Chapter II

Responses to Comments

1. Introduction

Comment CHATTEN-2 7

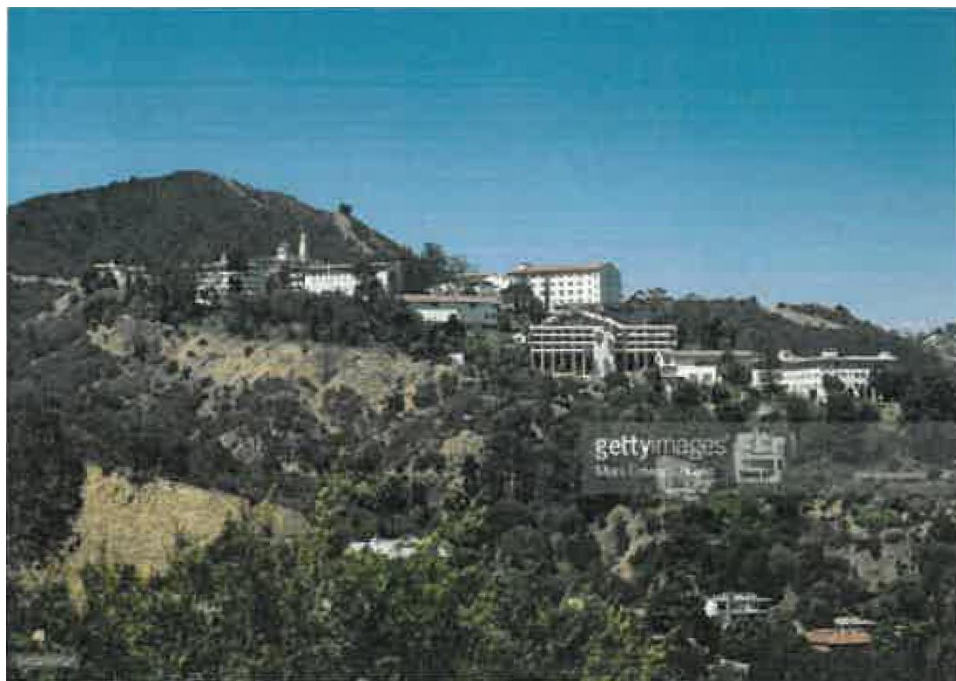
The Chalon Campus of Mount St. Mary's University.

Comment REUBEN 2 (e-mail on May 1, 2018)

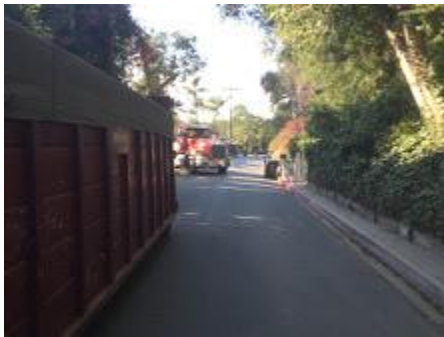
Enclosed are photographs off Norman Place taken on different days showing either heavy equipment on the street or construction workers parking and blocking the street, leaving only one way to pass. This is just the work on one house that has caused enormous disruption and delay. The St Mary's project would make things much worse on this street.

Refer to Response to Comment Reuben 1 above for a discussion of traffic impacts.
